The Arcade and 18-20 Corporation Street and 17 Foundry Street, Dewsbury

Summary of Amendments

Doc No. 1705-BDP-AD-XX-RG-Z-00005
Revision: P01
Date: 18 June 2026

DATE FIRST ISSUED 15/11/21
DRAWING No. 1705-RDP-18-77-PI -A-00002-	REVISION P07

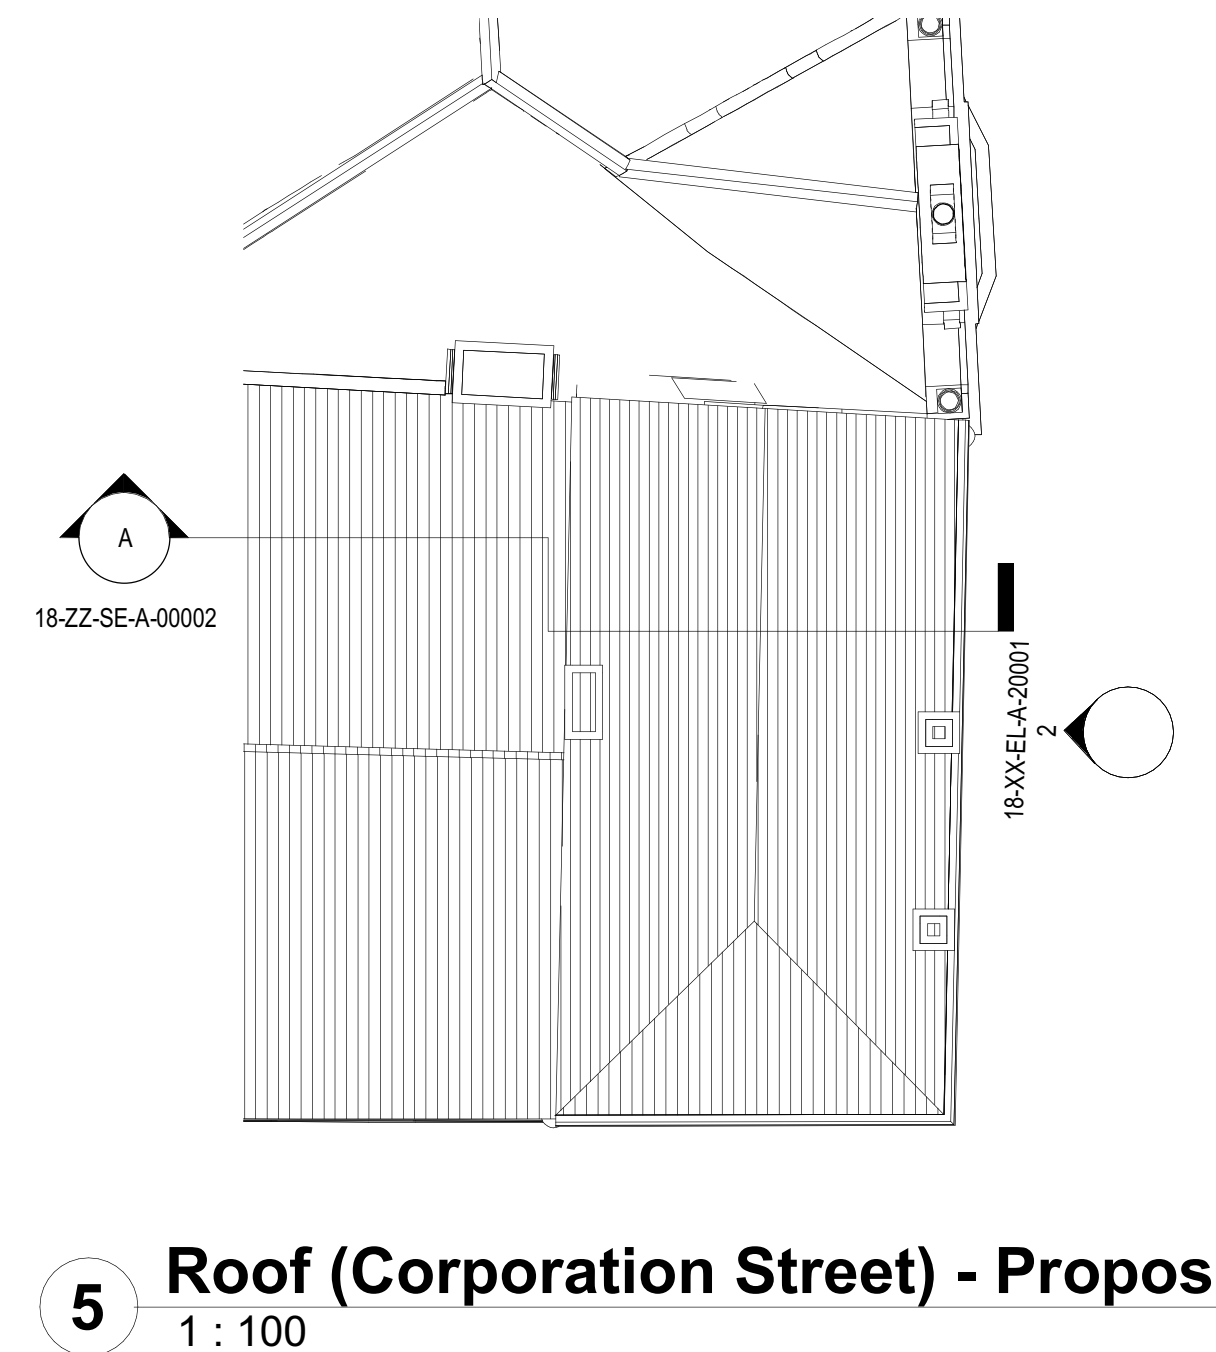
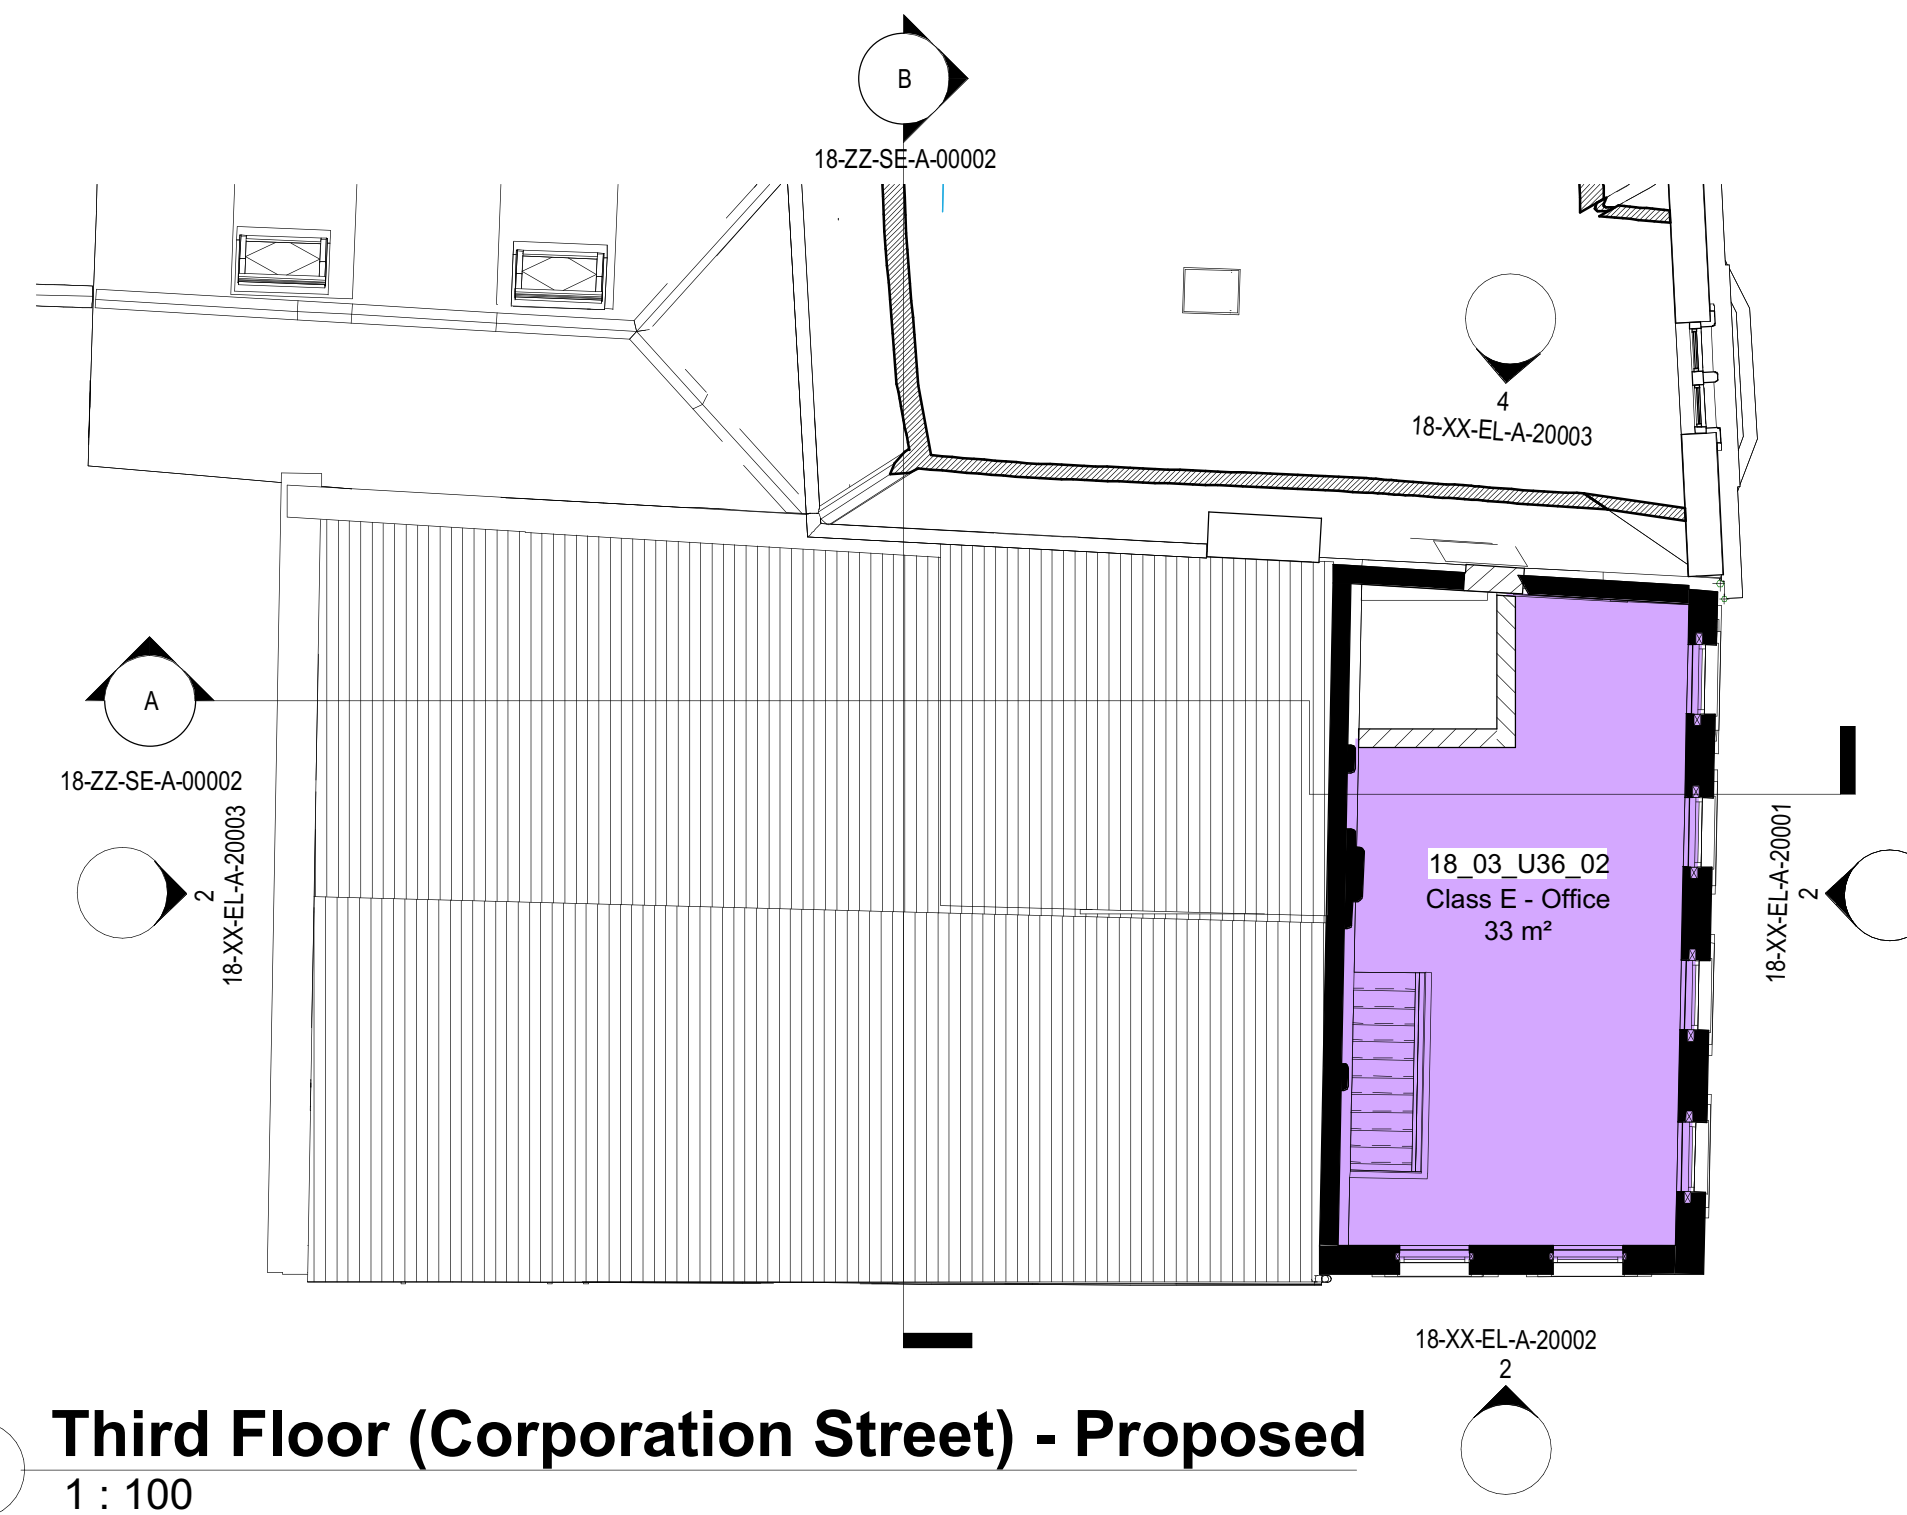
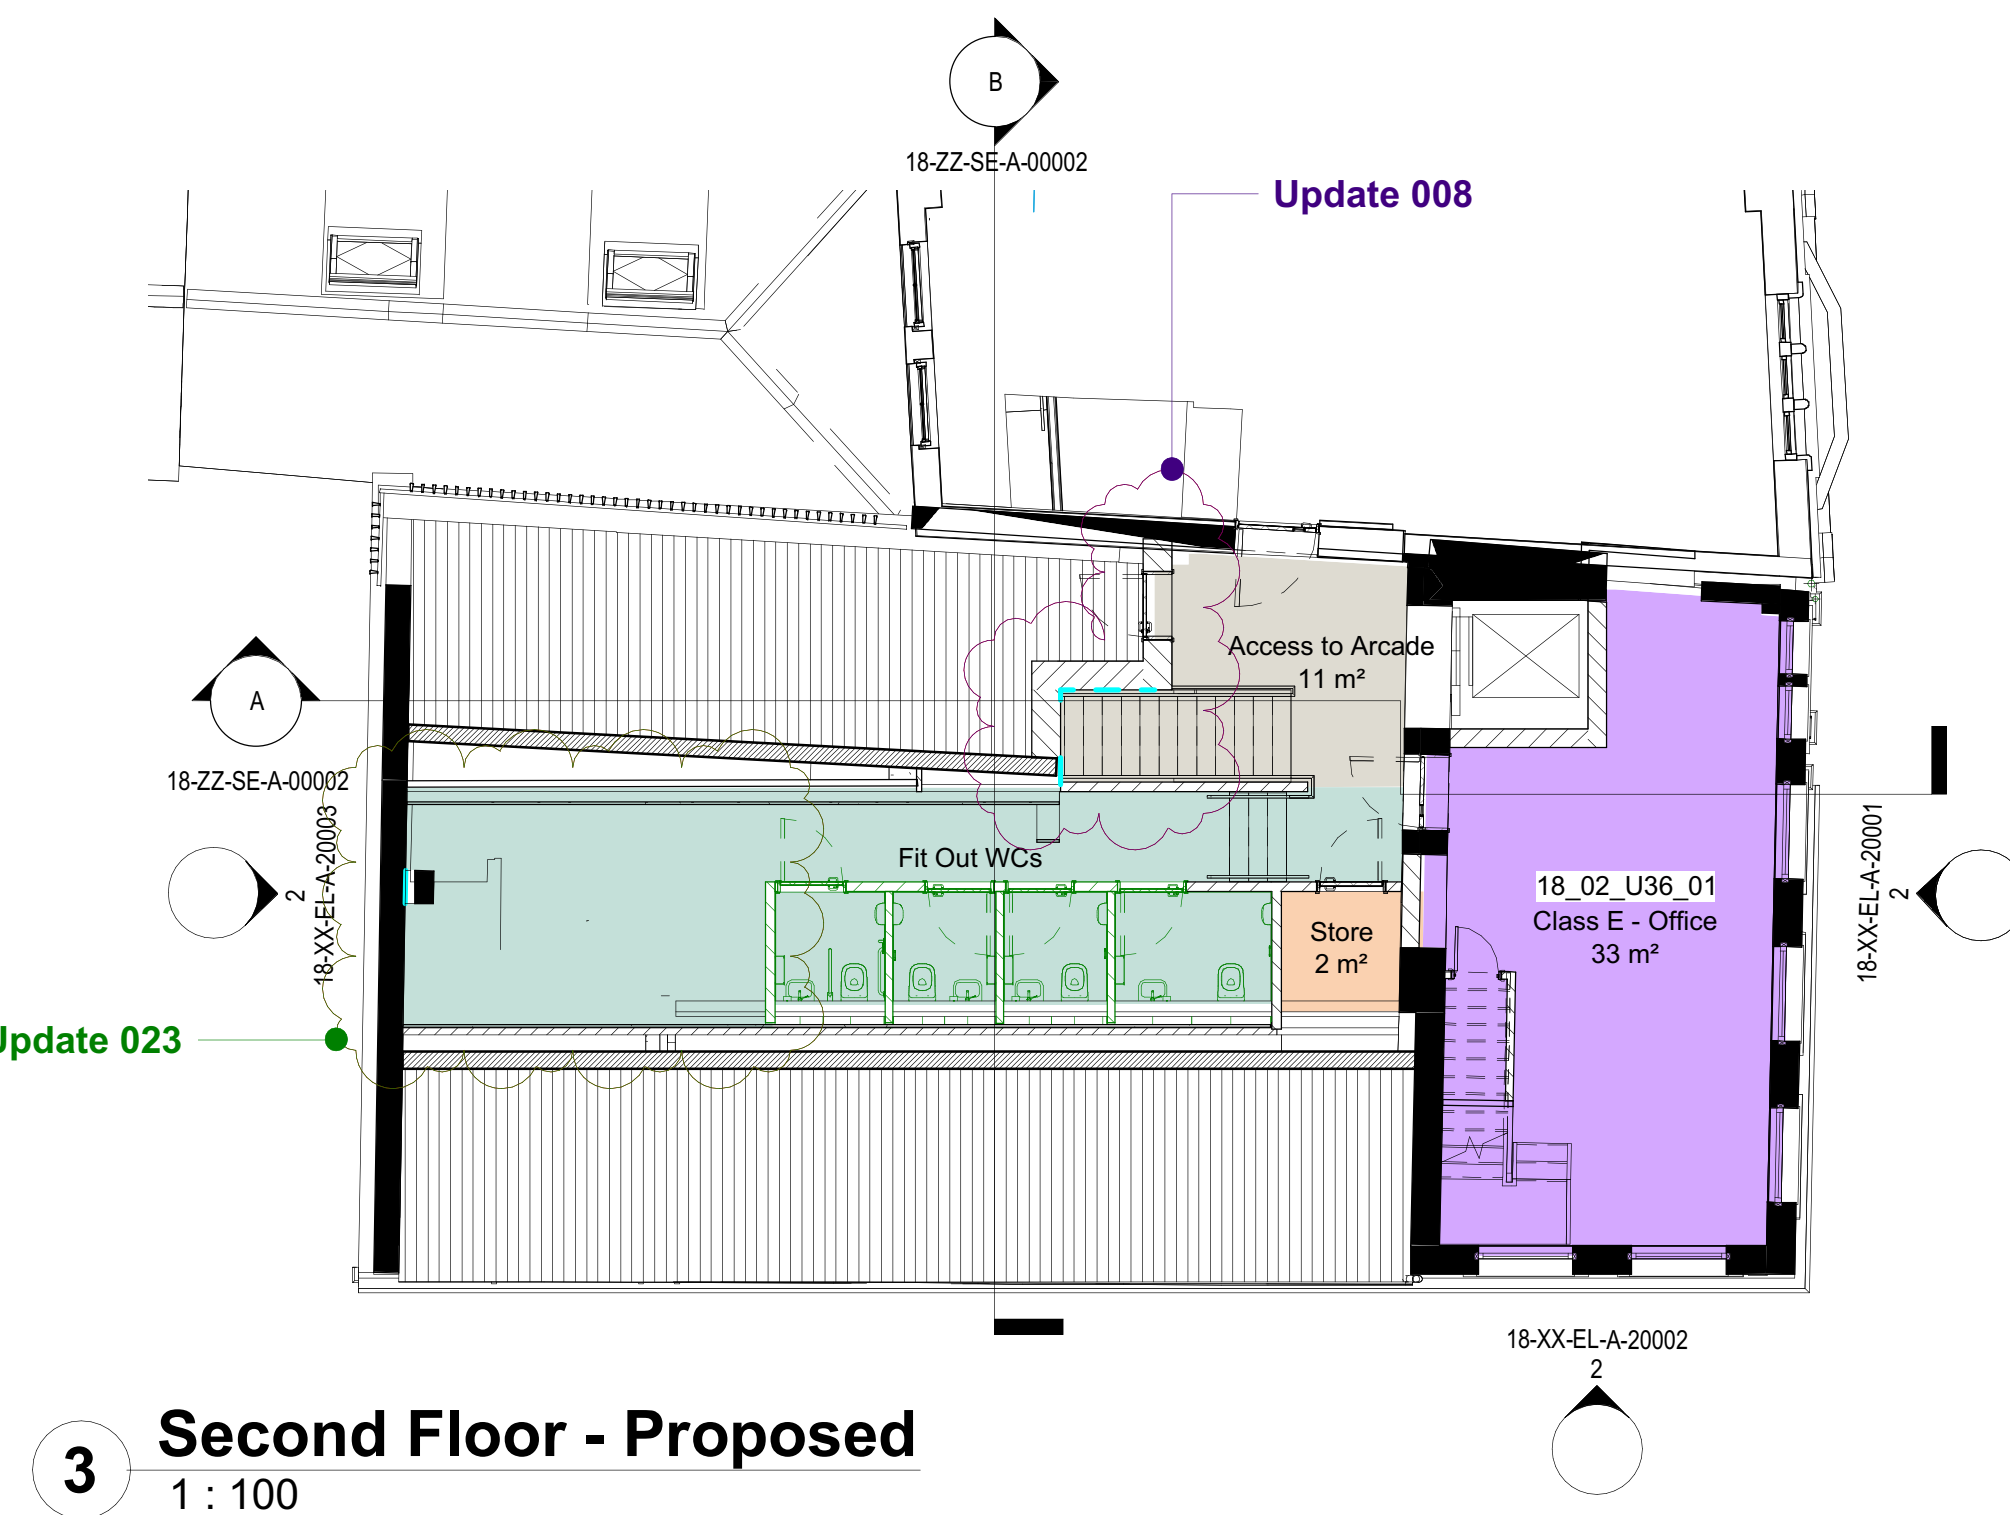
008	17 Foundry Street	Roof	Replace an area of the existing pitched roof (facing away from the principal elevation) with an area of flat roof to provide increased headroom for a new staircase.	The profile of the existing pitched roof and the timber purlins beneath the common rafter extend further into the proposed stair area than previously known.	The extent of the previously proposed roof would not provide sufficient headroom at the head of the new stair.	Slightly increase the extent of this area of flat roof. Note that this will still remain entirely at the rear of the building so will not affect the roof slope on the principal elevation to Foundry Street.	1705-BDP-AD-02-PL-A-20001_T01 1705-BDP-AD-03-PL-A-20001_T01 1705-BDP-18-ZZ-PL-A-00002_P06 1705-BDP-18-ZZ-SE-A-00002_P02 1705-BDP-18-SL-PL-A-00003_P02	1705-BDP-AD-02-PL-A-20001_T02 1705-BDP-AD-03-PL-A-20001_T02 1705-BDP-18-ZZ-PL-A-00002_P07 1705-BDP-18-ZZ-SE-A-00002_P03 1705-BDP-18-SL-PL-A-00003_P03

028	18-20 Corporation Street and 17 Foundry Street Units 32-36	Ceilings and walls	Repair damaged ceilings and walls.	The ceilings and wall finishes were found to be in a poorer state than expected, incorporating modern materials and with extensive damp.	Where present, plaster had debonded from the laths and masonry and therefore was not suitable for patch repair. There is also a need to treat dry rot in the masonry, requiring plaster to be removed.	Remove damaged ceiling finishes and replace with plasterboard finishes. Remove damaged wall finishes and replace with lime plaster. This approach has already had consent elsewhere in the arcade buildings.	1705-BDP-18-ZZ-PL-A-00002_P06	1705-BDP-18-ZZ-PL-A-00002_P07
029	17 Foundry Street Unit 33	Shopfront	Replace modern shopfront to match appearance of the original shopfront.	A structural column has been in part of the existing shopfront construction.	This column clashes with the proposed splayed door opening.	Minor change to the alignment of the splayed door opening.	1705-BDP-18-ZZ-PL-A-00002_P06	1705-BDP-18-ZZ-PL-A-00002_P07
